SITE INSTRUCTION

SI A08

PROJECT : Forestside
PROJECT # : 1331.15
DATE : Sep. 09, 2021

Title: Revisions to plans as itemized.

1:50 CS302c1

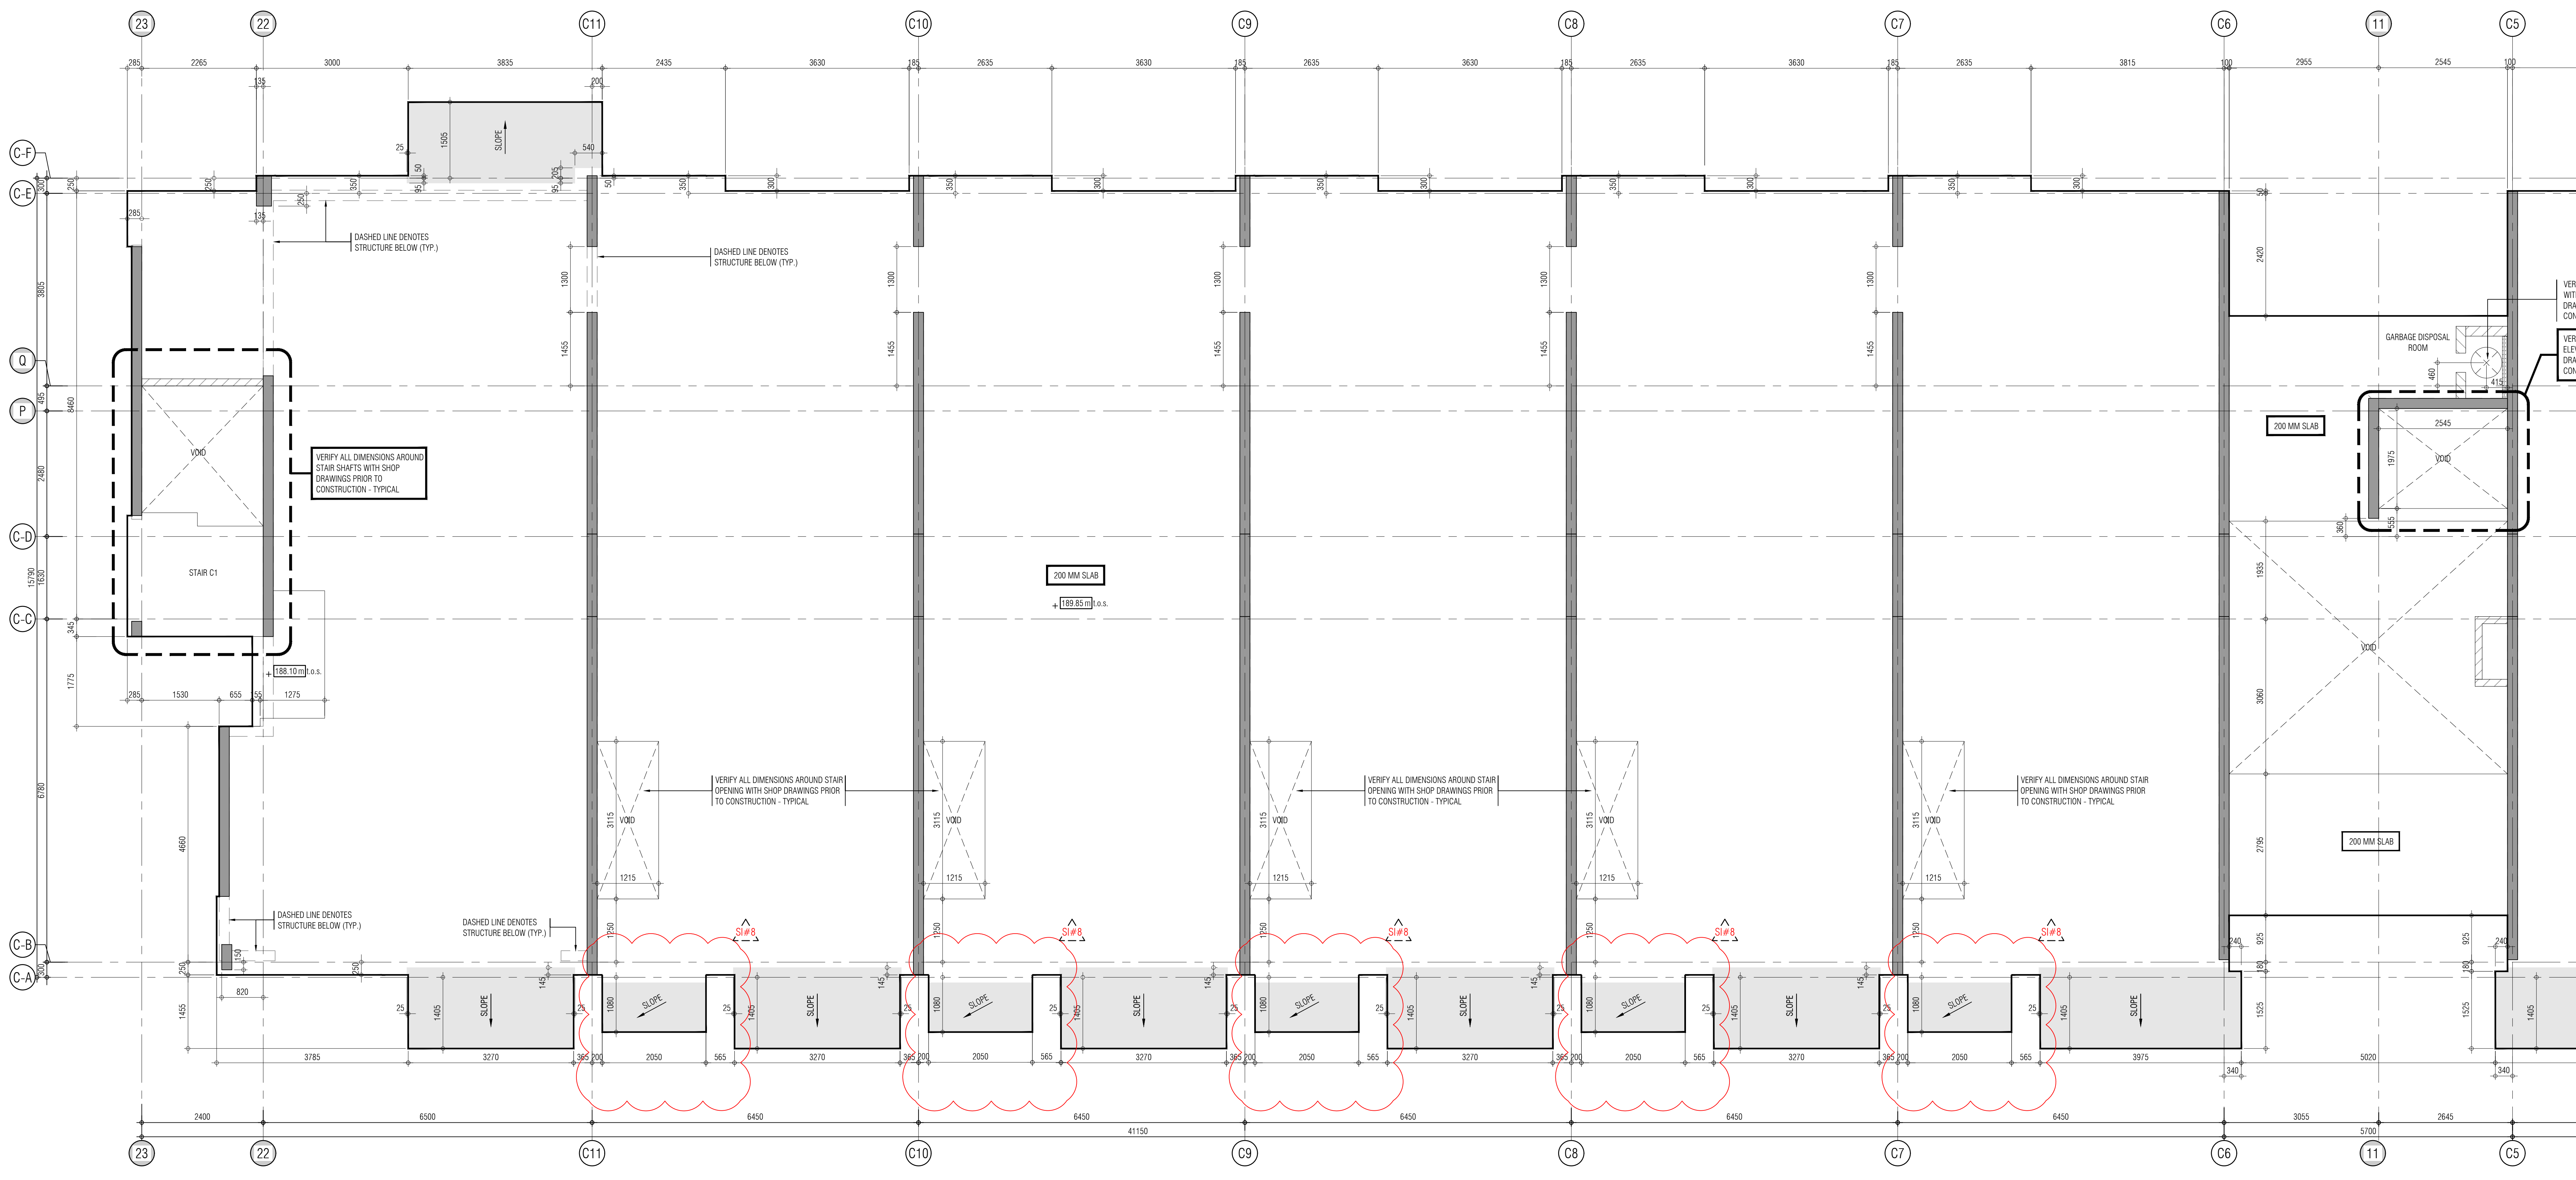
Reference:		Changes:
CS302C	2nd Floor Slab Edge Bldg. C	Revise Concrete canopy size over front door entrance building C.
A302, A320c1, A302 c2	2 nd Floor Plans Bldg. C	Revise Concrete canopy size over front door entrance building C.
A301, A301c1. A301c2	1 st Floor Plans Bldg. C	
A403, A403c1	Elevations	Revise Concrete canopy size over front door entrance building C.
A900	Window Schedule	Revised window schedule as per updated plans and elevations.
